<b>In the Matter of the Appeal of the</b>	<b>)</b>	<b>FILE NO: LU 16-159330 LDS EN</b>
<b>Hearings Officer's Approval of</b>	<b>)</b>	
<b>EVERETT CUSTOM HOMES, INC.'S</b>	<b>)</b>	
<b>Application for Subdivision Approval</b>	<b>)</b>	
<b>and Environmental Compliance</b>	<b>)</b>	
<b>Review</b>	<b>)</b>	
<b>(Type III Proceeding)</b>	<b>)</b>

**HAYHURST NEIGHBORHOOD  
ASSOCIATION'S MEMORANDUM  
IN OPPOSITION TO 11-LOT  
SUBDIVISION, AS PROPOSED**

**Date:** March 7, 2017  
**To:** Hearings Officer  
**From:** Stephanie Beckman, Senior Planner, Land Use Services  
Phone number: 503-823-6979  
**Re:** LU 16-159330 LDS EN, EVERETT HEIGHTS SUBDIVISION

Aerial map of site with GPS location of springs

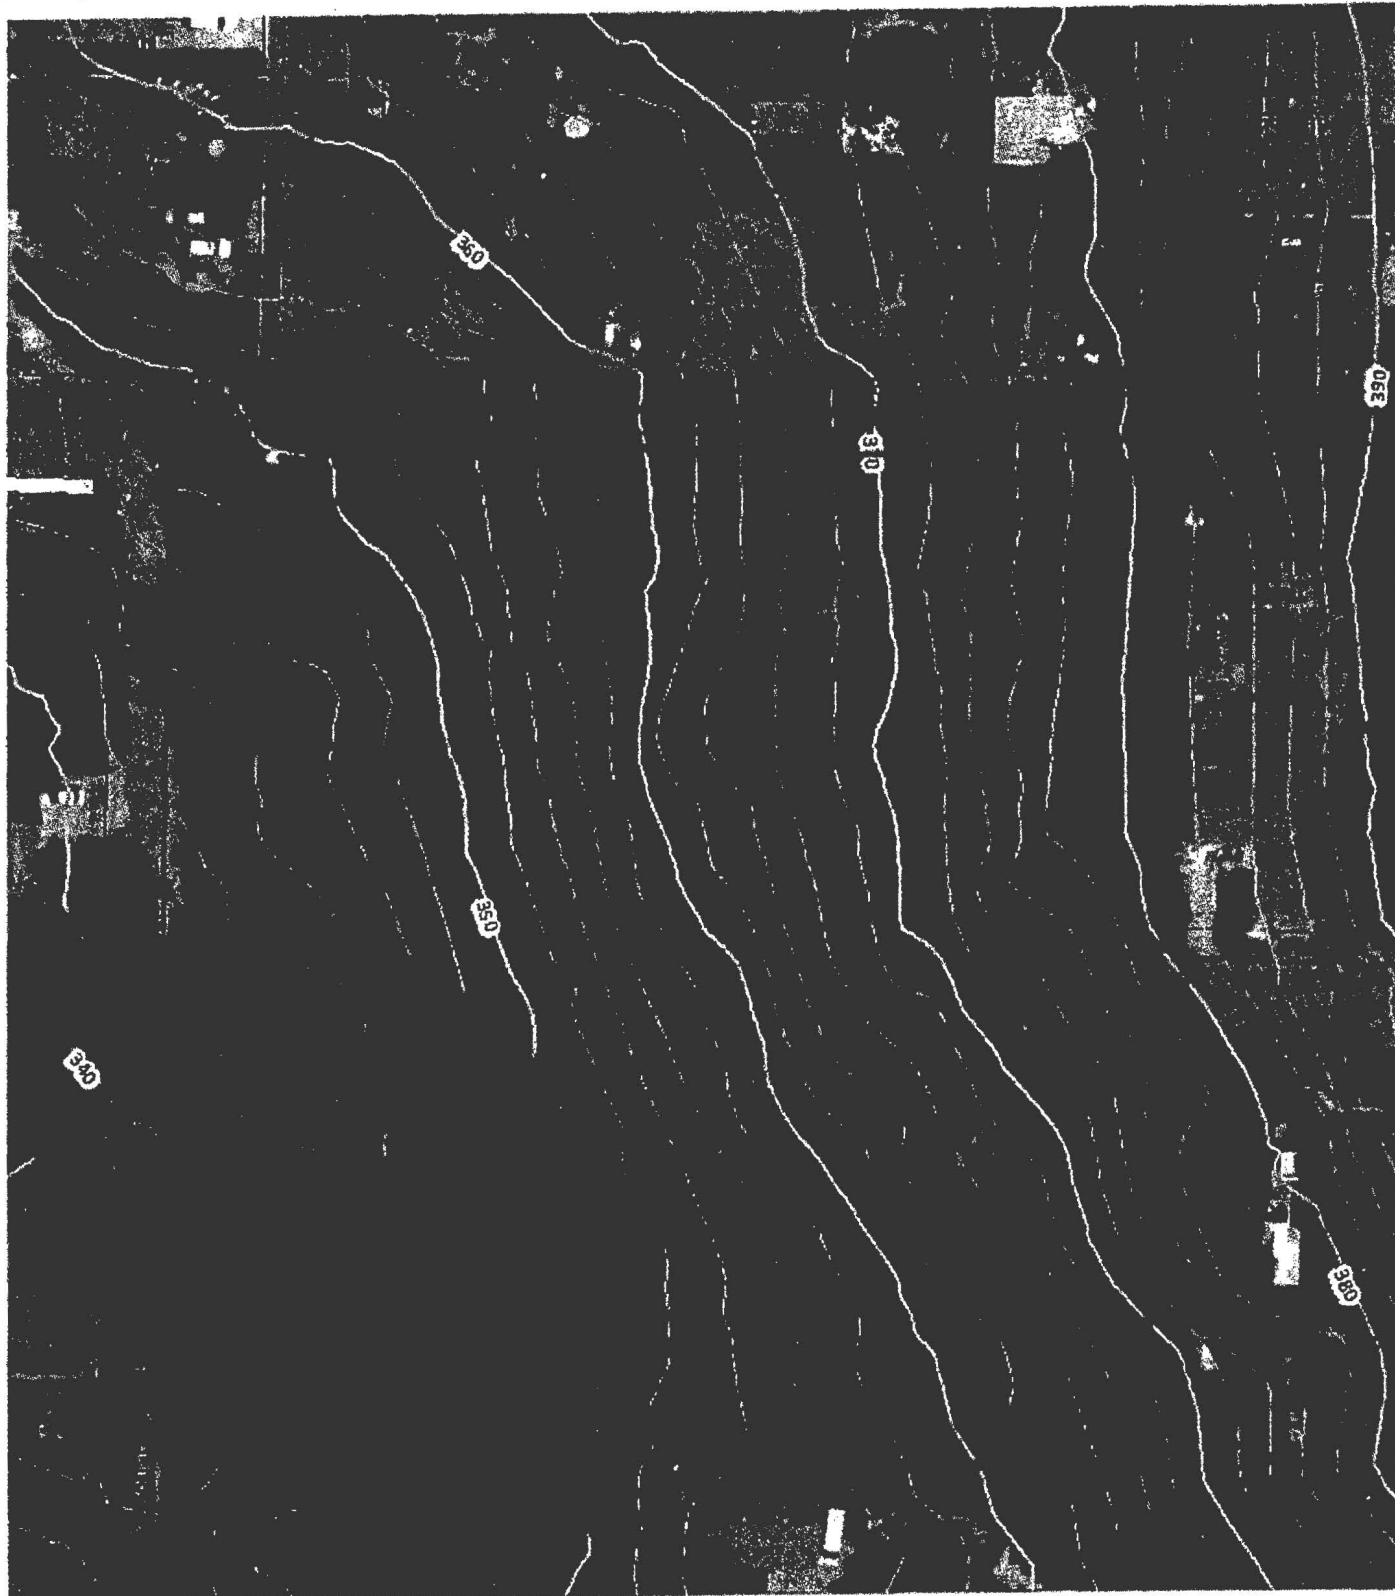
An additional site visit was conducted on March 1, 2017 in response to phone calls and emails from neighbors to Bureau of Environmental Services staff with concerns about water resources on the site. At that site visit, springs were identified by BES staff and located using a hand-held GPS device (see attached email and map). Based on this information, it appears as though some of the identified springs are outside of the environmental conservation overlay zone boundary, and therefore may be subject to the regulations of 33.640. However, as noted by BES staff, the accuracy of the GPS device is not exact and it is recommended that the applicant provide a surveyed location to determine where the springs are located.

The exact location is important because seeps or springs (as defined in 33.910) that are located outside of the environmental zone, must be placed in a tract and preserved in their natural state per 33.640. Any seeps or springs located within the environmental overlay zone are subject to 33.430 and would be preserved within Tract A under the current proposal.

Based on the information from BES staff described above, there are outstanding questions about whether 33.640 applies. It should also be noted that this issue could impact other

During our sight visit on March 1<sup>st</sup> 2017, I noticed several springs flowing toward the delineated wetland. This spring flow and low depth to groundwater are likely what provides the hydrology for the wetland. I used a Trimble GPS to map the location of the springs. It appears that a majority of the springs are either within the wetland or within the environmental tract with the exception of three springs. Two of these three springs were not flowing and were located within a test pit the applicant said was dug for infiltration testing. It appeared these two springs had enough flow to scour soils from beneath adjacent vegetation roots. But it is not clear whether those springs would have presented as surface water if the test pit were not dug in that location. The springs may have instead remained under ground and as groundwater flow. The third spring however, was flowing at the time of the site visit. I took a video of the flow and mapped its location. Please see the attached map. What is unknown is the accuracy of the GPS point. Since the spring location is so critical for this development, the applicant may need to have the spring(s) professionally surveyed, which would get it to sub-centimeter accuracy. If so, I can go back out to the site and flag the location of the spring(s).

- Survey the location of identified seeps in the field to determine if they are within or outside of the environmental overlay zone;
- Provide an evaluation by a qualified professional as to whether the identified features must be preserved based on the regulations of 33.640 and, if so, the appropriate location of the tract boundary and limit of disturbance; and
- Update the plans and other materials as needed to respond to any changes required to the site plan.
